BEV HORDERN

Submission ID: 216560

Ref : SSD 9409987 Plasrefine Recycling Facility Moss Vale

Fig 2 page 3 Ref 2.
Potential impacts of roller door being open for short periods of time

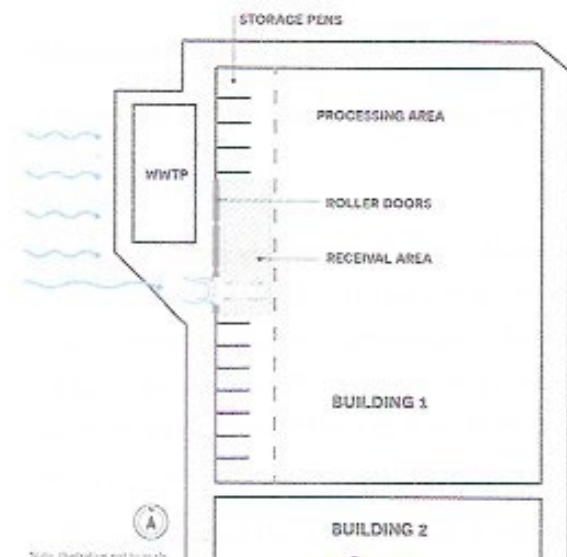
INCONSISTENT DIAGRAMS PROVIDED BY GHD TO IPC.

GHD is claiming that the WWTP will protect door openings from westerly winds. HOWEVER the most recent diagram shows that the doors have moved.

Fig 1 page 2 Ref 2
Ref 2: Response to DPPII from GHD re Roller Door Opening Times November 15, 2024

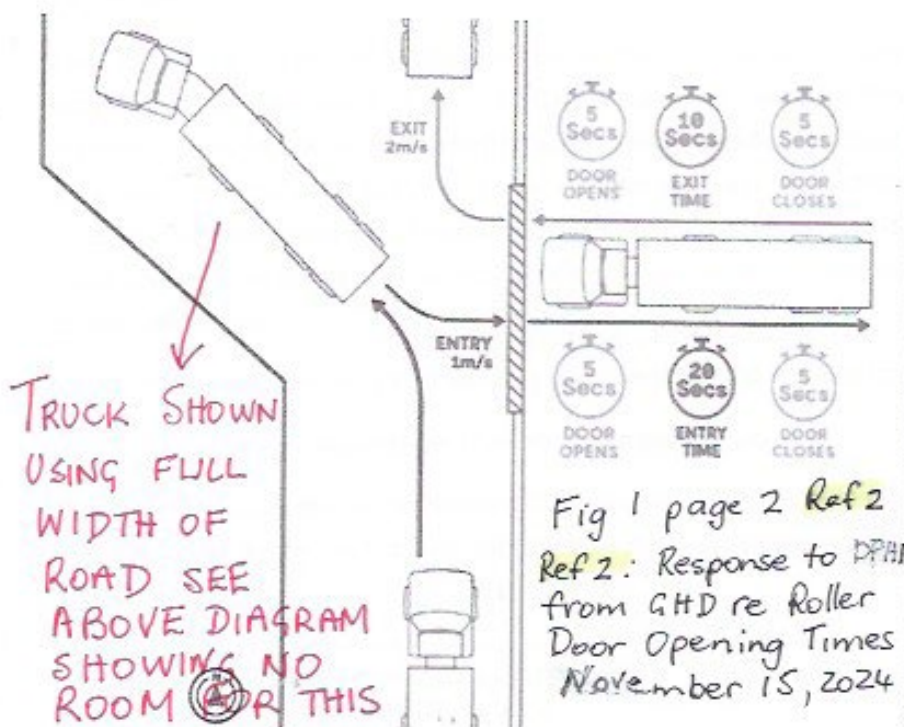
Throughout this whole (four year) process, every time information is received from GHD, there are omissions, unexplained changes, inadequate diagrams and conflicting information. Here I wish to draw the IPC’s attention to the **discrepancies** in the positioning of the three roller doors, critical to the claim that the Waste Water Treatment Plant (WWTP) will provide protection from the westerly winds shown in one diagram in a document dated Nov 15, 2024 but then the doors have been moved in a document provided ten days later. I also question the claim that a truck will reverse into the facility in ten seconds when there is just not room to do that in one movement. I have done my best to explain this visually on the following page.

FIGURE ON LEFT INDICATING ROOM NEEDED FOR TRUCKS TO REVERSE INTO BUILDING IN 20 SECONDS.

THE ABOVE DIAGRAM SHOWS THAT WITHOUT THIS ADDITIONAL WIDTH OF 'ROAD' TRUCKS WILL TAKE MUCH LONGER TO REVERSE.
